ADDENDUM No. 1 TO PLANS AND CONTRACT DOCUMENTS

**EAST MARSH ISLAND MARSH CREATION
POST-CONSTRUCTION MAINTENANCE EVENT**

CWPPRA NUMBER: TV-21

APRIL 4, 2014

| COASTAL PROTECTION AND RESTORATION AUTHORITY 450 LAUREL ST. STE. 1501 BATON ROUGE, LOUISIANA 70801 | | EAST MARSH ISLAND MARSH CREATION POST-CONSTRUCTION MAINTENANCE EVENT | | EAST-WEST CANAL ACCESS LAYOUT |

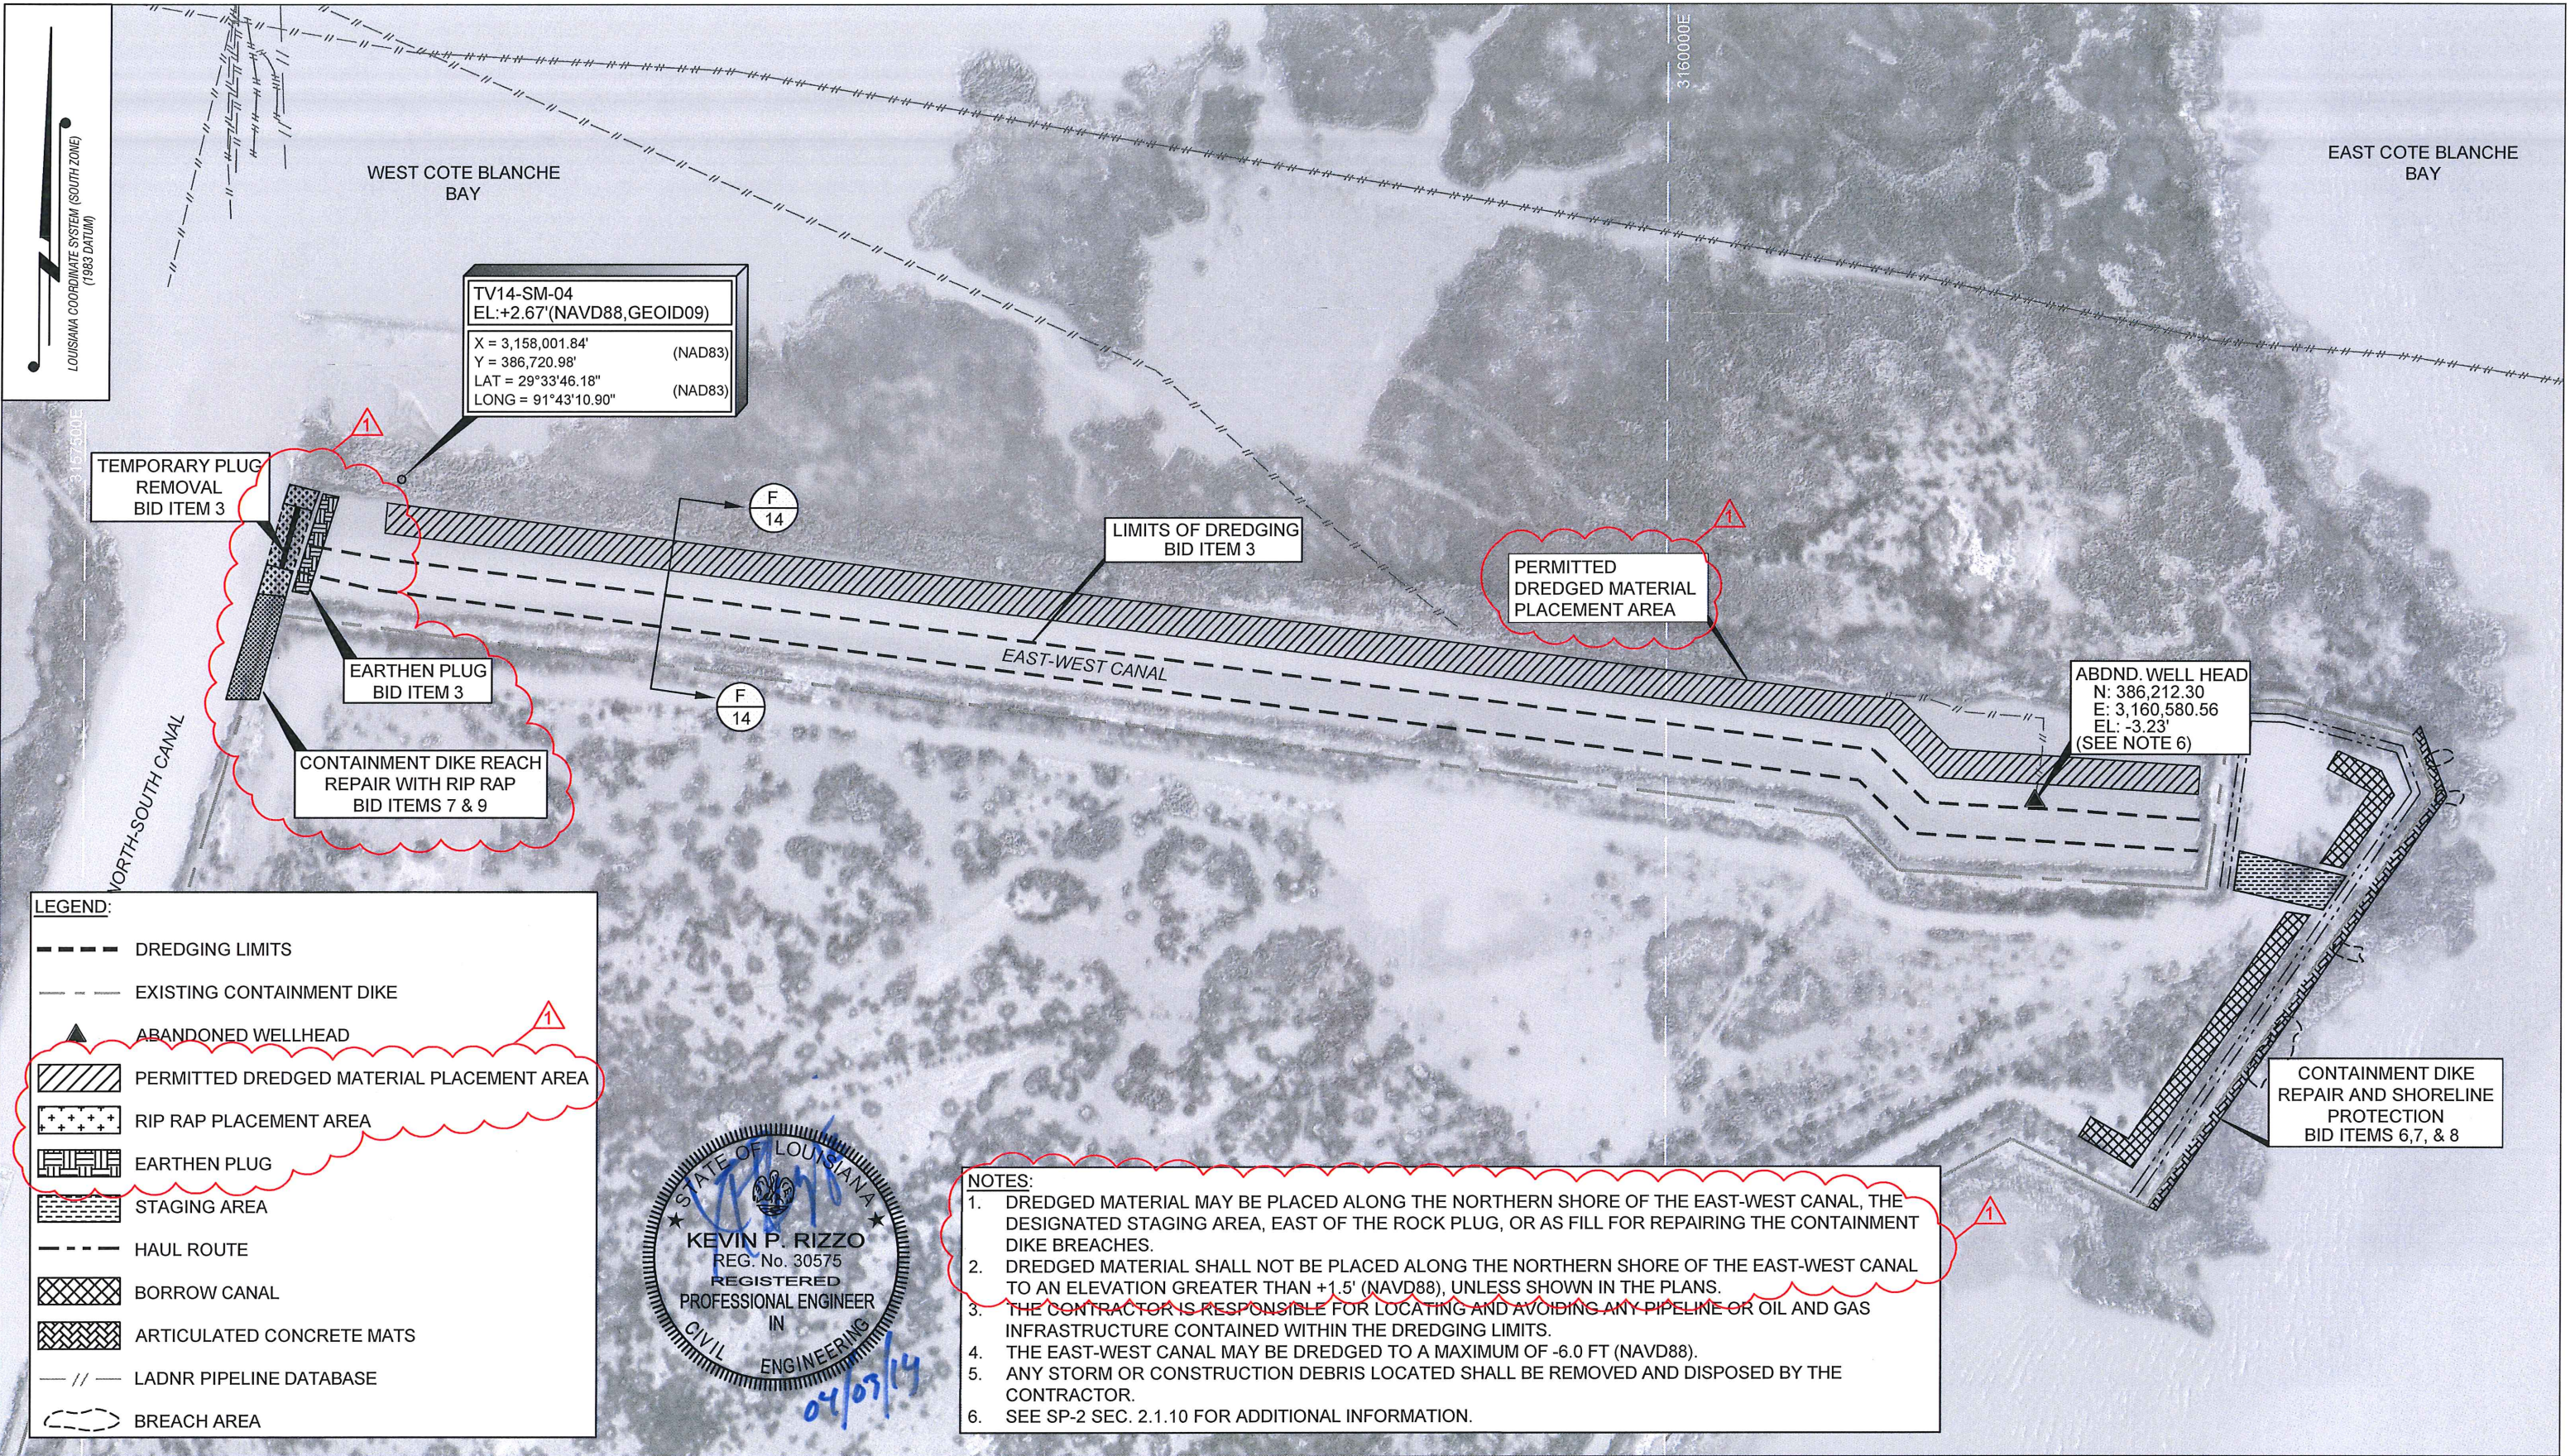
- 1.2. The proposed earthen plug just east of the rock plug being temporarily relocated (See Plan Sheets 6 & 7) has been resized. An earthen plug shall be constructed to a +1.5 ft. (NAVD88) with a minimum crest width of 25.0 ft. See Plan Sheets 6, 7, and 14 for details. Payment for the earthen plug shall be included in the lump sum Bid Item No. 3 “ACCESS AND FLOATATION DREDGING & PLUG REMOVAL”

- 1.3. A question regarding Note 5 on Plan Sheet 8 was discussed. Dredging of the North-South Canal shall be strictly limited to wheel-washing or minor dredging to allow direct access to the Rock Plug. This dredging is permitted, with approval from the ENGINEER, if found compliant with the consistency permit issued for original construction of the project. The material dredged from the North-South Canal shall not be used as a fill or a borrow source.

1. DREDGED MATERIAL MAY BE PLACED ALONG THE NORTHERN SHORE OF THE EAST-WEST CANAL, THE DESIGNATED STAGING AREA, EAST OF THE ROCK PLUG, OR AS FILL FOR REPAIRING THE CONTAINMENT DIKE BREACHES.
2. DREDGED MATERIAL SHALL NOT BE PLACED ALONG THE NORTHERN SHORE OF THE EAST-WEST CANAL TO AN ELEVATION GREATER THAN +1.5' (NAVD88), UNLESS SHOWN IN THE PLANS.
3. THE CONTRACTOR IS RESPONSIBLE FOR LOCATING AND AVOIDING ANY PIPELINE OR OIL AND GAS INFRASTRUCTURE CONTAINED WITHIN THE DREDGING LIMITS.
4. THE EAST-WEST CANAL MAY BE DREDGED TO A MAXIMUM OF -6.0 FT (NAVD88).
5. ANY STORM OR CONSTRUCTION DEBRIS LOCATED SHALL BE REMOVED AND DISPOSED BY THE CONTRACTOR.
6. SEE SP-2 SEC. 2.1.10 FOR ADDITIONAL INFORMATION.

TEMPORARY ROCK PLUG
REMOVAL AND BREACH
REPAIR LAYOUT

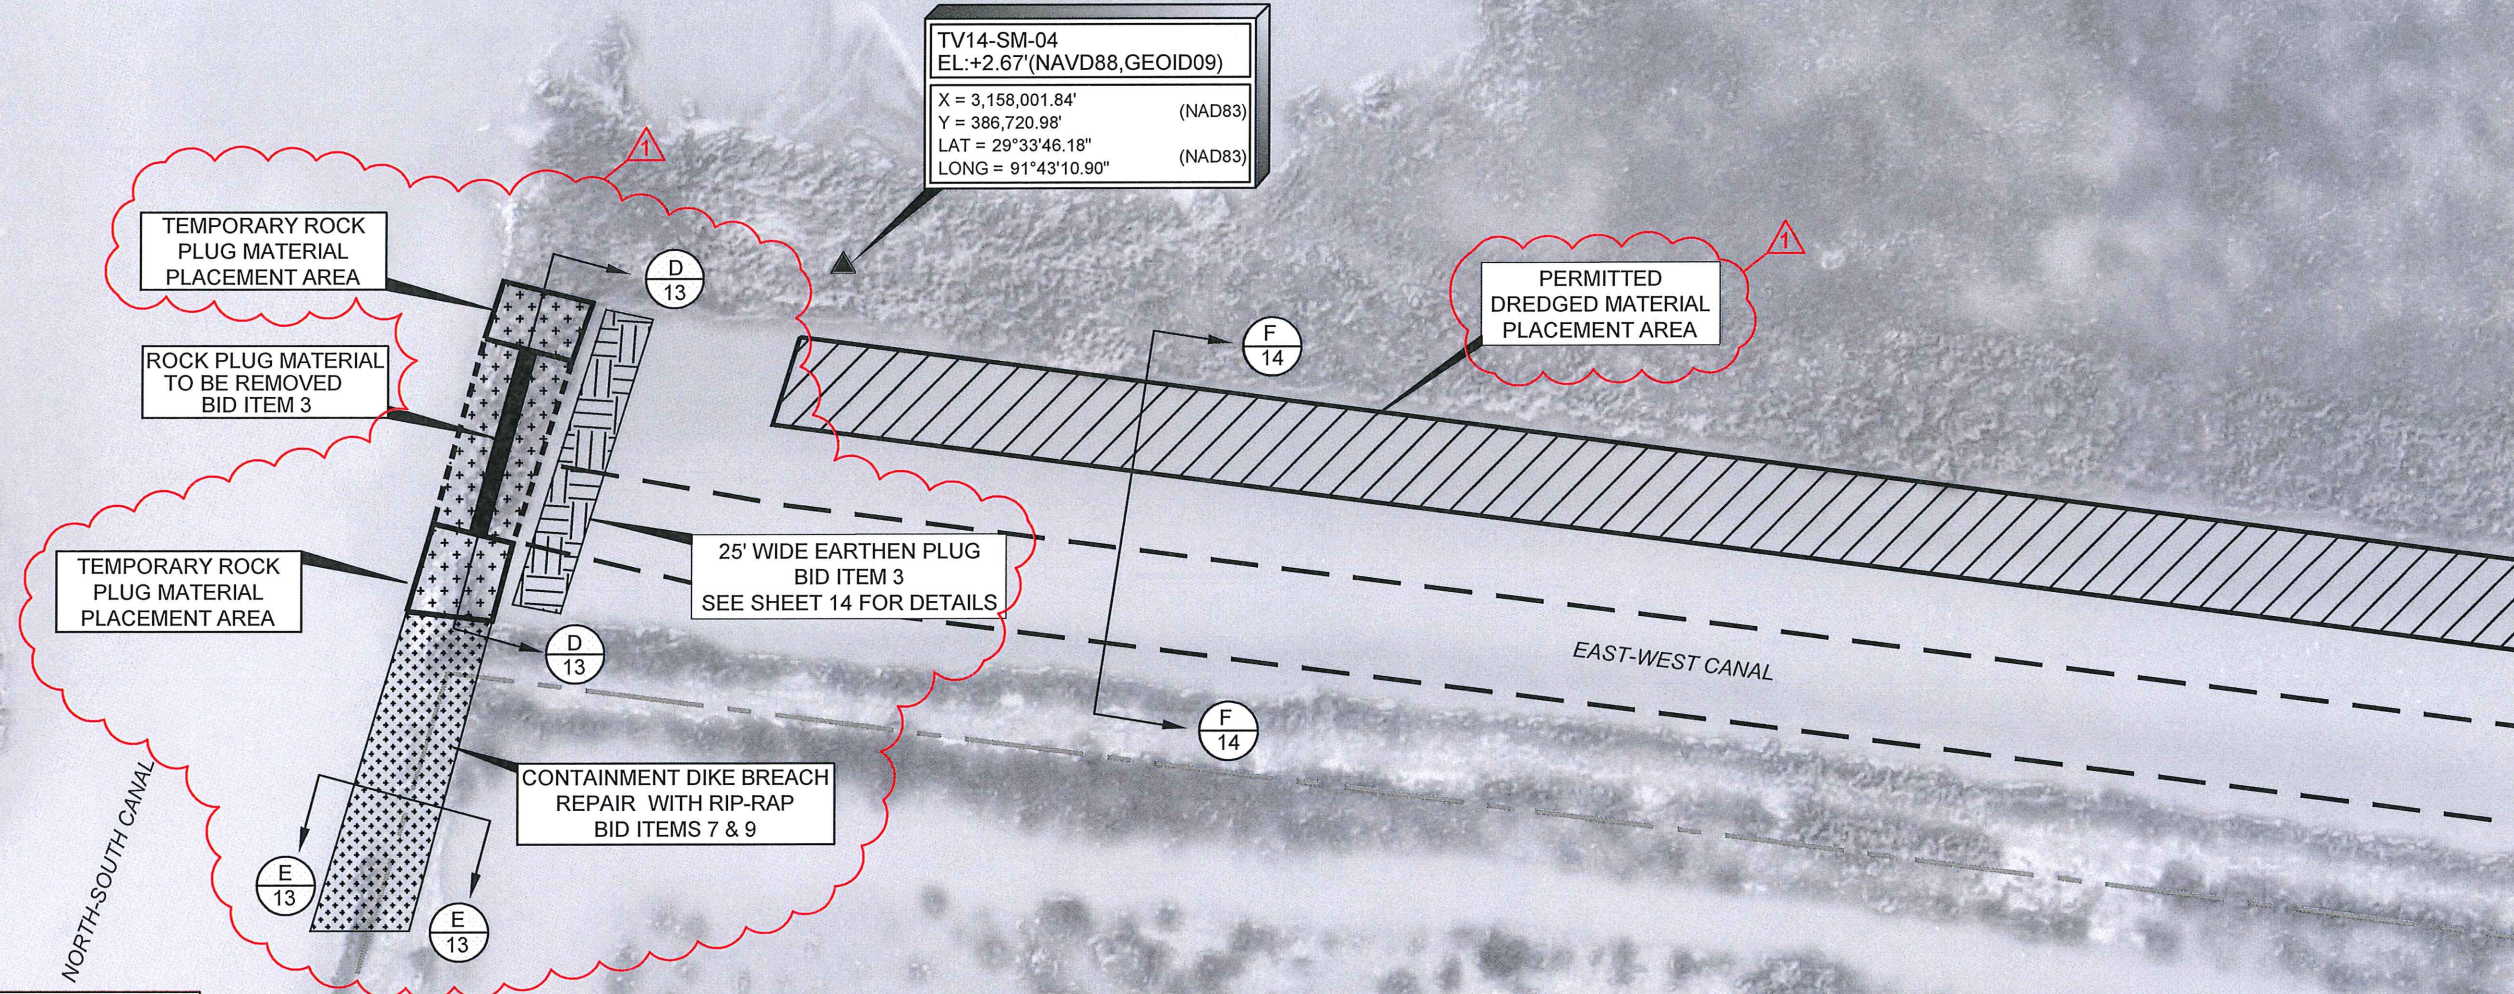
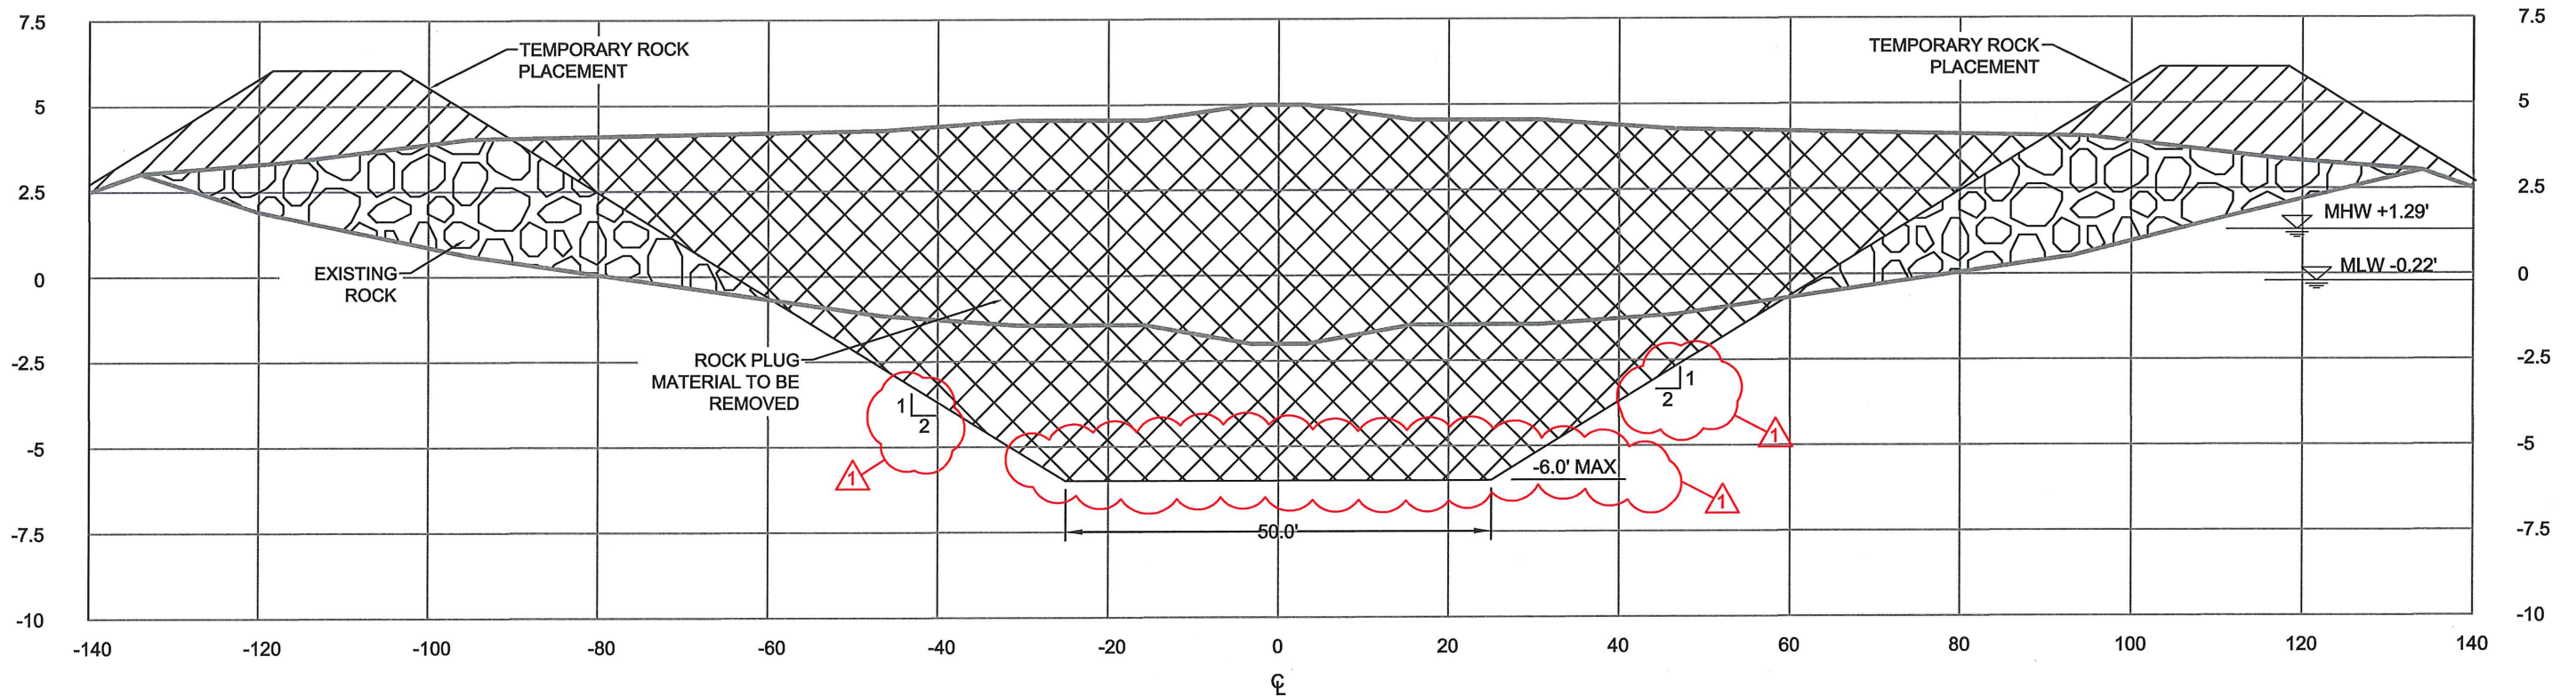
- 1.1. The Plans and Specifications will be updated to clarify the material replacement of the rock plug shall be **to** the pre-construction surveyed lines, grades, and elevations.

- 130-lb CLASS RIP-RAP SHALL BE USED AS FILL FOR THE CONTAINMENT DIKE BREACH REPAIR. SEE TS-9 OF THE SPECIFICATIONS FOR DETAILS.
- RIP RAP SHALL BE PLACED TO THE LINES, GRADES, AND ELEVATIONS SHOWN IN TYPICAL SECTION E-E.
- RIP-RAP WILL BE PLACED OVER GEOTEXTILE FABRIC AS SHOWN IN TYPICAL SECTION E-E AND STATED IN TS-9 OF THE SPECIFICATIONS.
- EXTENTS OF THE CONTAINMENT DIKE BREACH MAY BE ALTERED BY THE ENGINEER TO FIELD FIT CONDITIONS DURING CONSTRUCTION. ANY ADDITIONAL QUANTITIES OF RIP-RAP SHALL BE PLACED AT THE UNIT RATE FOR BID ITEM 9.

- THE ROCK PLUG IS TO BE RECONSTRUCTED WITHIN THE LINES, GRADES, AND ELEVATIONS OF THE PRE-CONSTRUCTION SURVEY PRIOR TO DEMOBILIZATION.
- EXCAVATED ROCK PLUG MATERIAL MAY BE PLACED ON AREAS ADJACENT TO THE EXCAVATION AS SHOWN ON THE PLANS.
- DREDGED MATERIAL FROM THE EAST-WEST CANAL SHALL BE PLACED TO CONSTRUCT AN EARTHEN PLUG WITH A 25' WIDE CREST WIDTH TO A +1.5' ELEVATION EAST OF THE REPLACED ROCK PLUG, PAID THROUGH BID ITEM 3.
- ANY EXCAVATED MATERIAL SHALL NOT BE PLACED AS TO IMPEDE NAVIGATION OF EXISTING WATERWAYS.
- DREDGING OF THE NORTH-SOUTH CANAL SHALL BE STRICTLY LIMITED TO WHEEL-WASHING OR MINOR DREDGING TO ALLOW DIRECT ACCESS TO THE ROCK PLUG.
